Illinois Power Company
Clinton Power Station
P.O. Box 678
Clinton, IL 61727
Tel 217 835-8881

Docket No. 50-461

Subject: Clinton Power Station
Proposed Resolution of Issues Related
to NRC Review of Inservice Testing Program

Revised Relief Requests

RELIEF REQUEST 2008 (Revision 3)

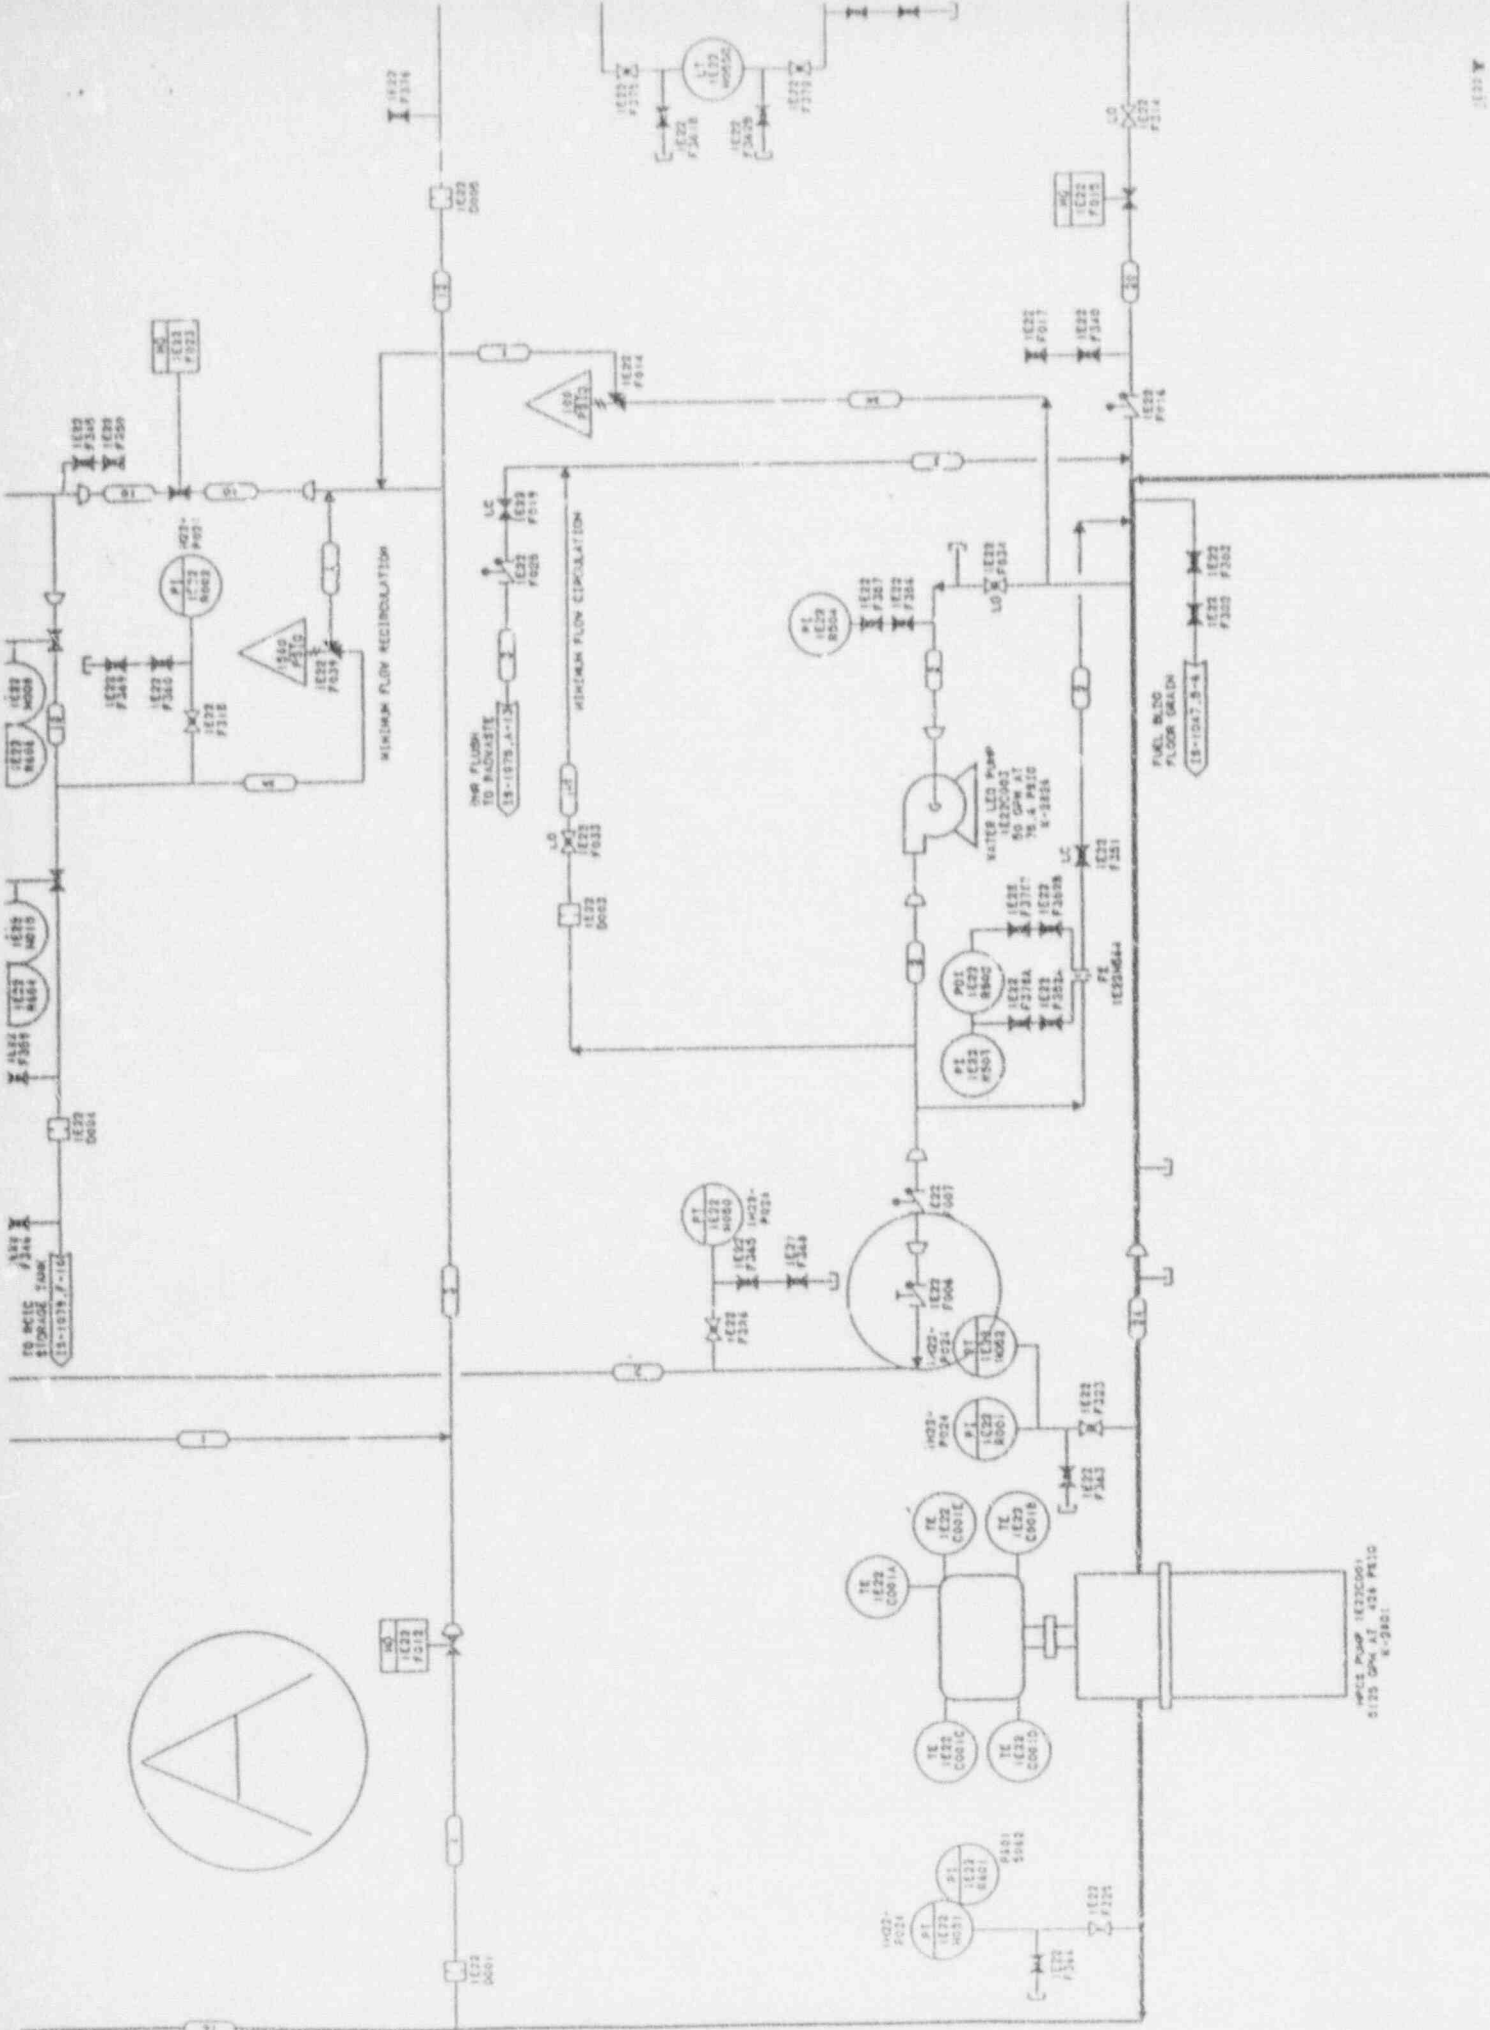
Valve 1E22-F006 is located between High Pressure Core Spray (HP) water-leg pump and the main HP injection line. It is a 2-inch stop-check valve, ASME Section III Class 2, Section XI Category C. It is circled on the attached drawing "A".

Valves 1E12-F085A,B,C and 1E21-F034 are located between the water-leg pumps and their respective injection lines (Residual Heat Removal (RHR) and Low Pressure Core Spray (LP)). They are ASME Section III Class 2, Section XI Category C valves. They are 2-inch stop-check valves of identical design. As their piping configuration is similar, only 1E21-F034 is circled on the attached drawing "B".

The above groups of valves, although located in separate systems, have similar configurations; they are check valves located in series with other check valves and no test connections provided between them to permit individual valve testing.

Each of these valves has a separate check valve in series. The two check valves in series, although not required by design or safety analysis, provide an added assurance that the high pressure Emergency Core Cooling System (ECCS) line will not damage the lower pressure water-leg piping. Illinois Power Company considers these two check valves in series as a single entity and will test them as such.

Illinois Power Company considers these two check valves in series a single entity and will perform the closure test every three (3) months as a single unit. Acceptance criteria will be established and in the event of not meeting this criteria, appropriate action will be initiated for the entity and the deficiency will be corrected.

The open exercise of these valves will also be performed every three (3) months.

RELIEF REQUEST 2033

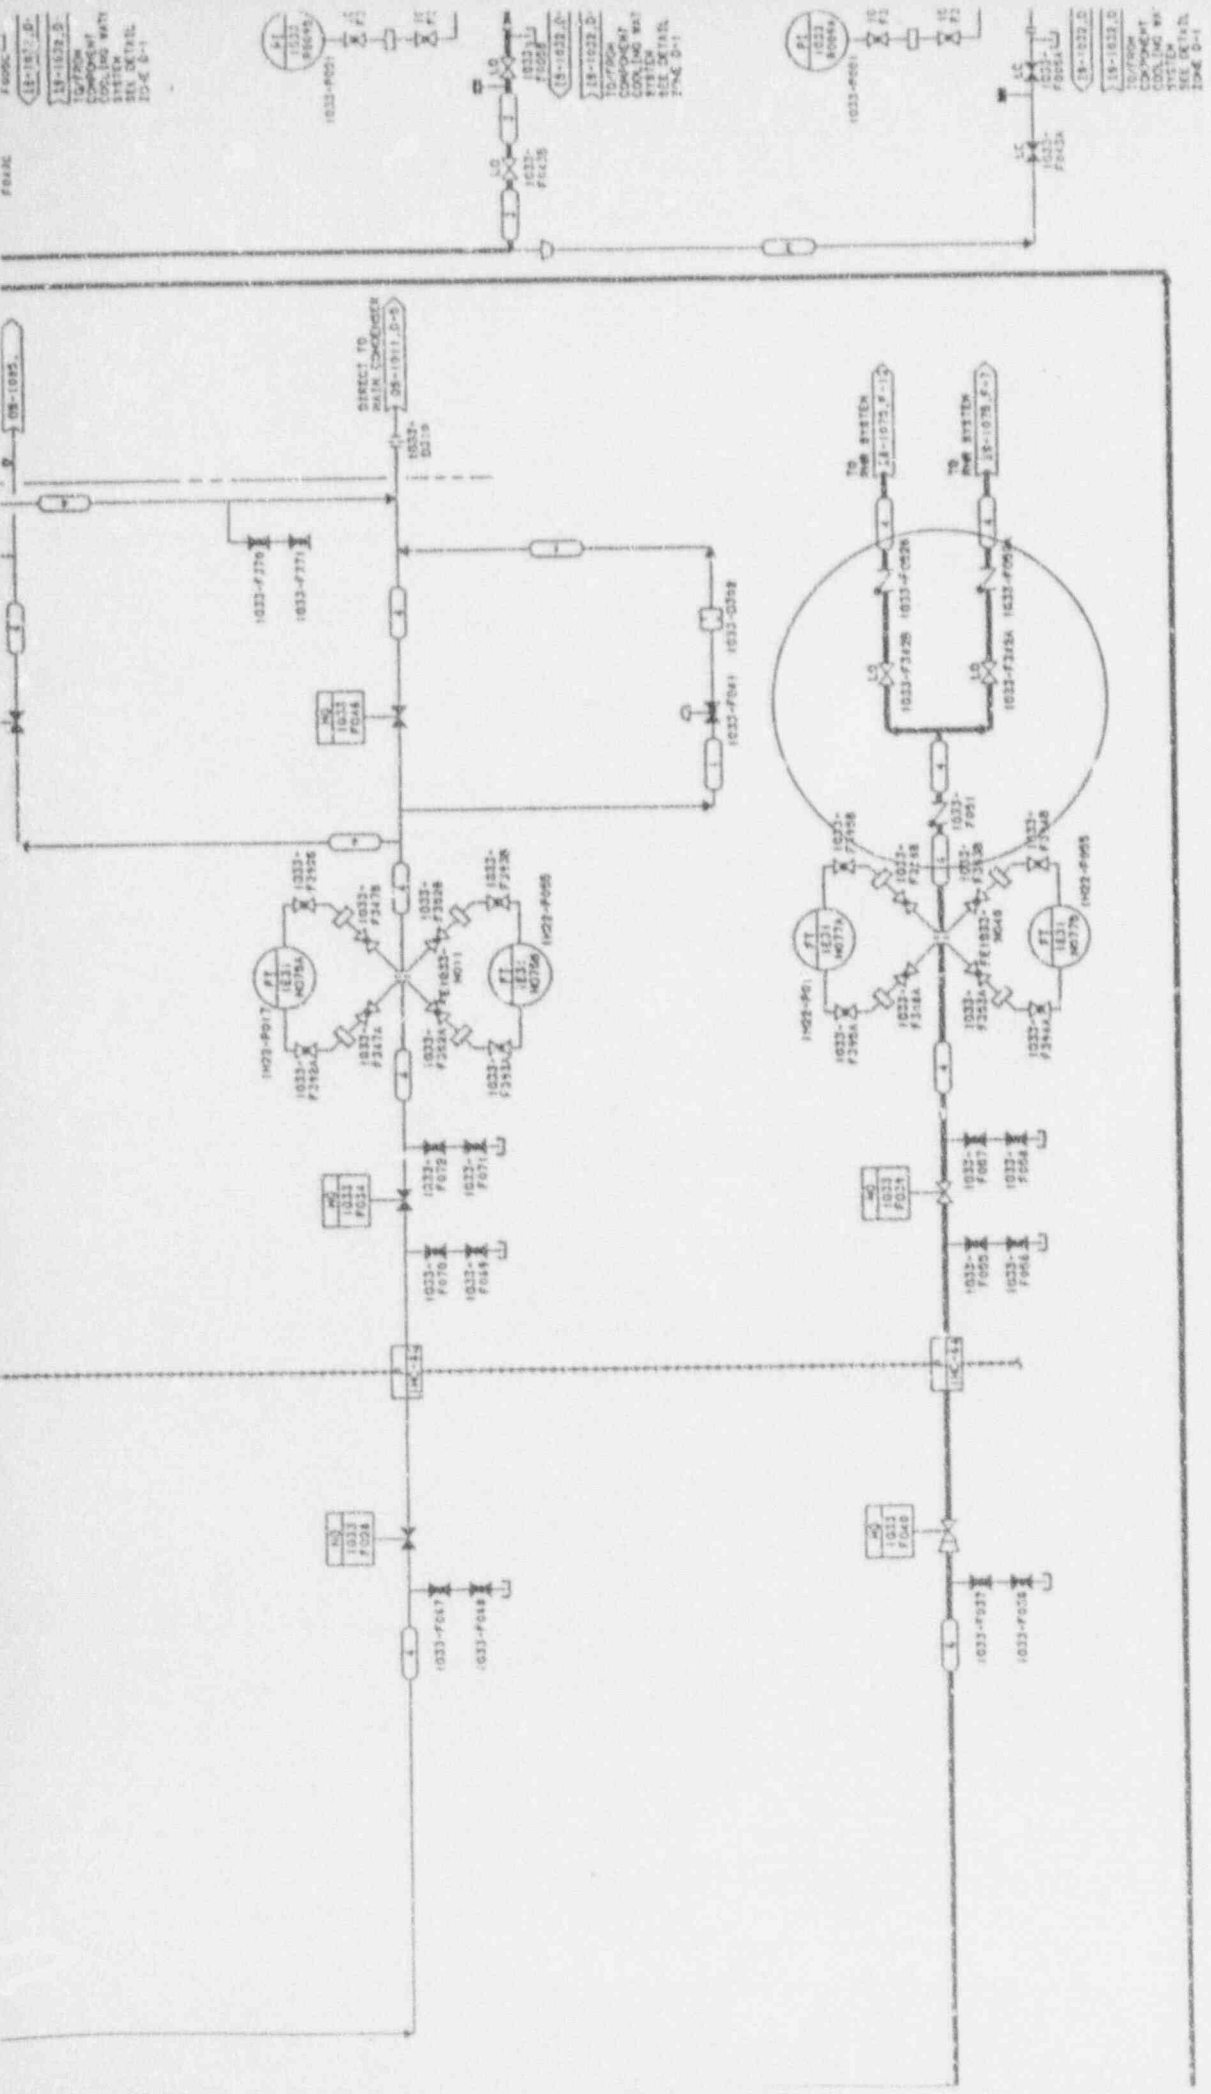
Valves 1G33-F051 and 1G33-F052A/B are the injection check valves which complete the flow path between the Reactor Water Cleanup (RT) System and the Reactor Pressure Vessel. These valves are ASME Section III Code Class 2, Section XI Category B valves. They are 4-inch check valves of identical design and are circled on the attached drawing.

1G33-F052A/B are parallel valves in the piping system and both of these valves are in series with 1G33-F051. These valves are located in series with no test connections provided between them to permit individual valve testing. Illinois Power Company considers valves 1G33-F052A and 1G33-F051 (both are in series) as a single entity and will test the valves as such. Valves 1G33-F052B and 1G33-F051 (both are in series) are also considered as a single entity for testing purposes and will be tested as such.

These units (valves) cannot be tested every three (3) months, since they are located in the Steam Tunnel and physical access is restricted during normal plant operation due to the high radiation field in this area. Testing these valves during cold shutdown will either require the Reactor Water Cleanup (RT) System to be out of service or will require flow to be bypassed to the condenser. Testing these valves with RT system flow bypassed to the condenser may create spurious differential flow signals and may cause containment isolation valves in this system to isolate and subsequently trip the RT pumps, which will likely require filing a Licensee Event Report (LER). Either method will cause the RT system to be out of service and create potential delay for plant startup. This will cause unnecessary hardship for Illinois Power Company without any significant gain in safety.

Illinois Power Company considers these check valves in series as a single entity and will perform the closure test every refueling outage as a single unit. Acceptance criteria will be established and in the event of not meeting this criteria, appropriate action will be initiated for the entity and the deficiency will be corrected.

(GRAPH 1)

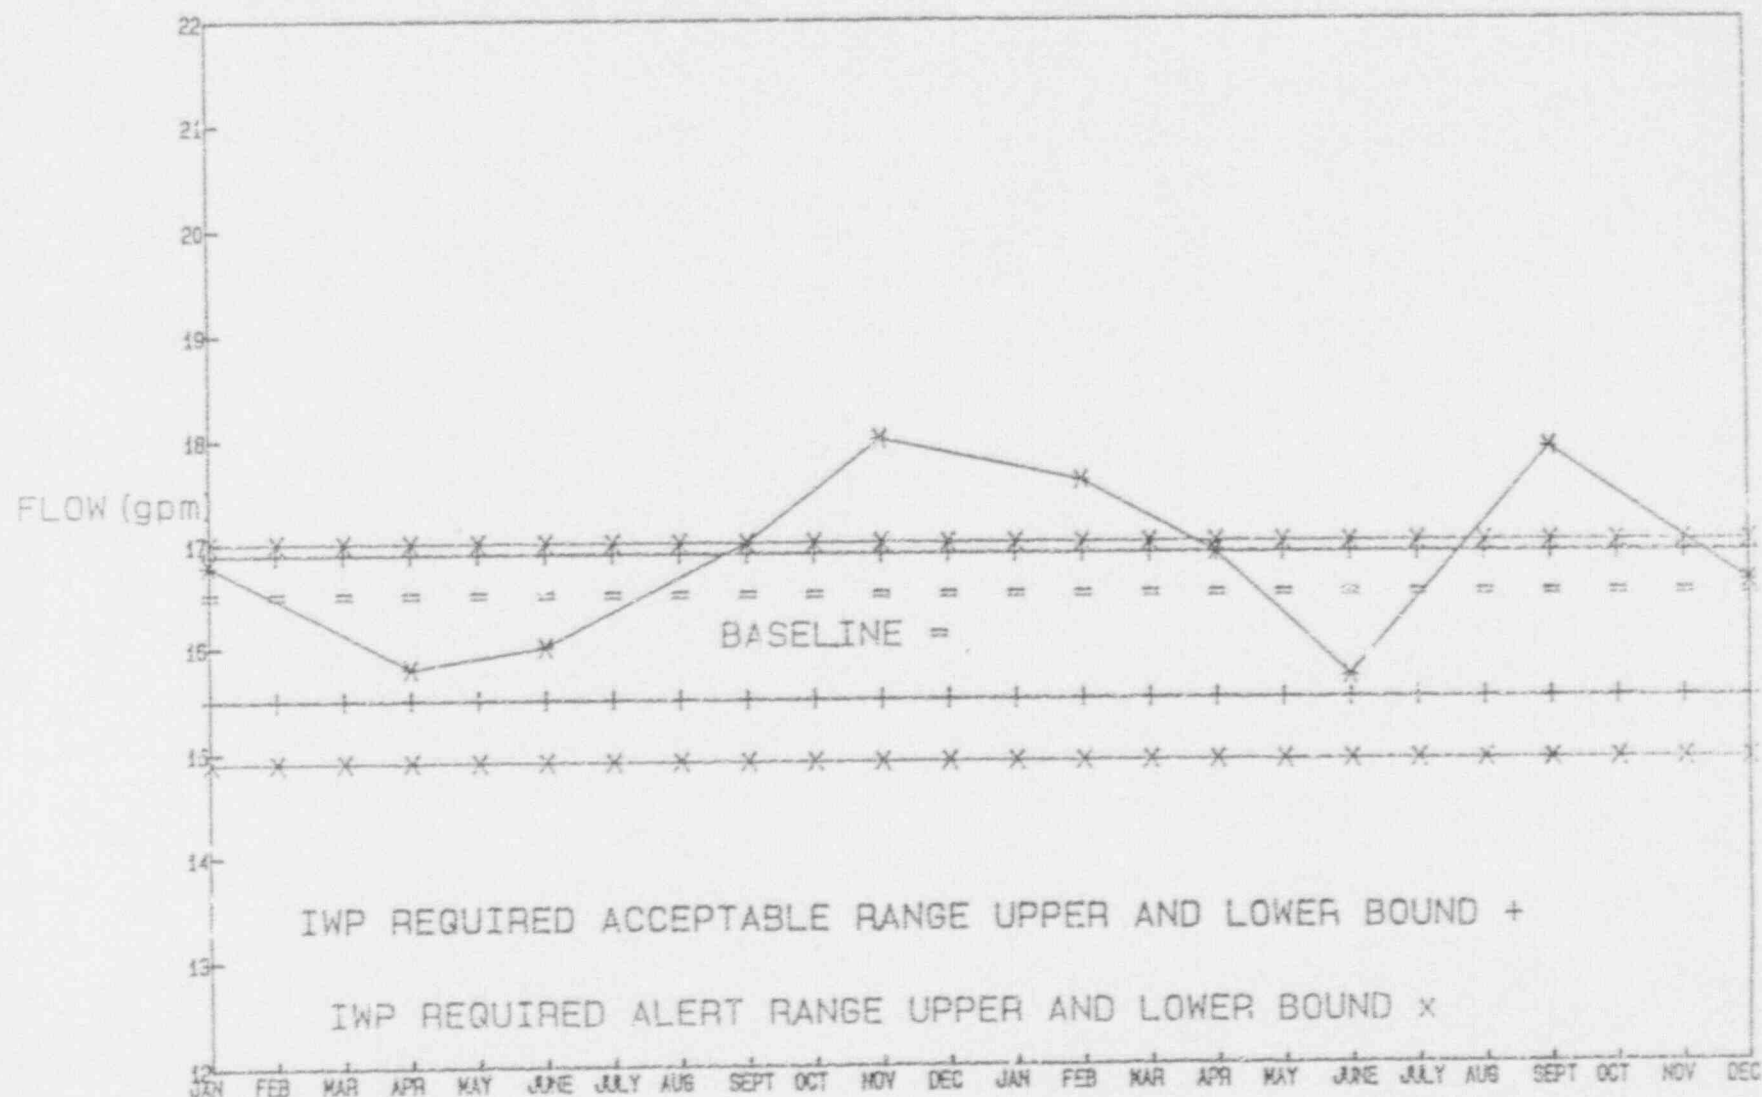
Because the DO pumps operate at a low flow and the Code specified acceptable ranges are based upon a percentage of the baseline, an increase in flow of less than 0.5 gpm ($1.02 \times$ baseline flowrate) is sufficient to force any of the pumps into the Required Action range. (SEE GRAPH 1)

(GRAPH 2)

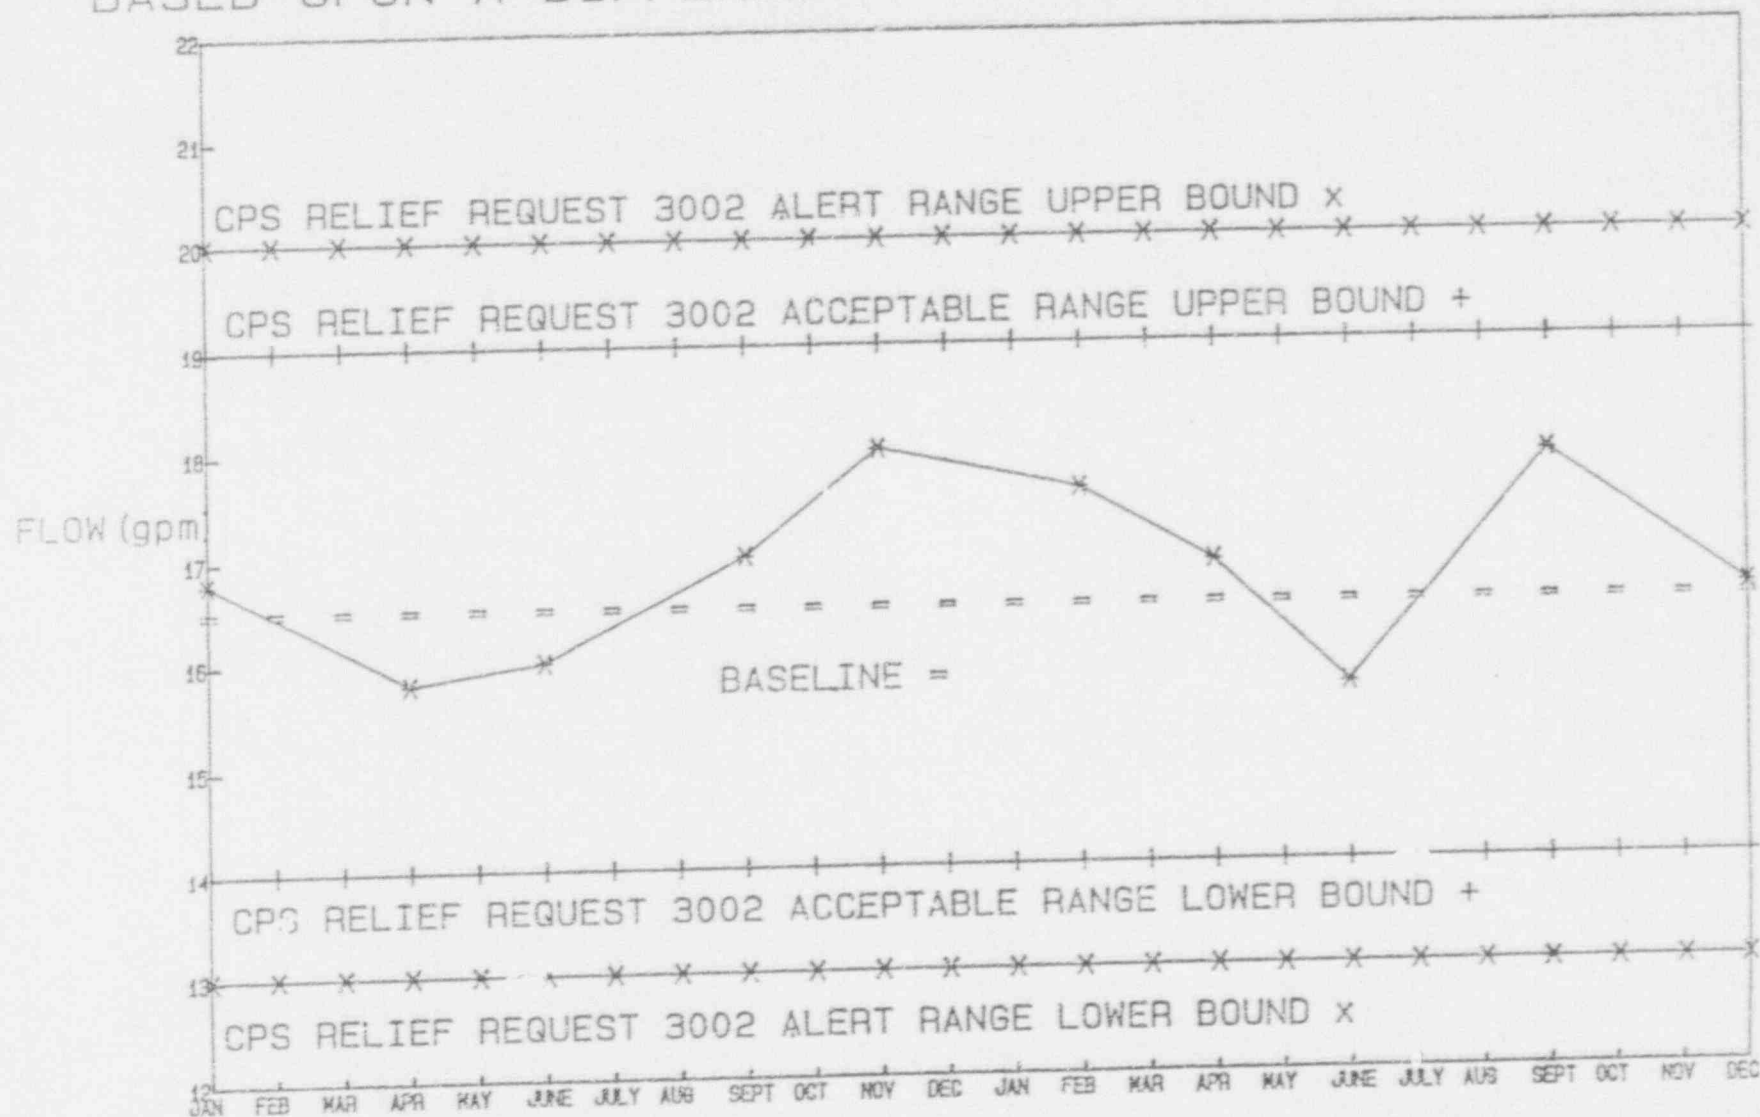
Based upon CPS's operating experience, CPS feels that the revised upper ranges will provide good indications of pump degradation without the unnecessary burden of requiring the pumps to be tested on an increased frequency or declared inoperable for minor (< 0.5 gpm) variations in flowrates. (SEE GRAPH 2)

Illinois Power will utilize the following Allowable, Alert, and Action ranges for Diesel Oil pump flowrates.

Acceptable Range	≥ 14 gpm and ≤ 19 gpm
Alert Range	≥ 13 and < 14 gpm or ≥ 19 and < 20 gpm
Action Range	< 13 gpm > 20 gpm
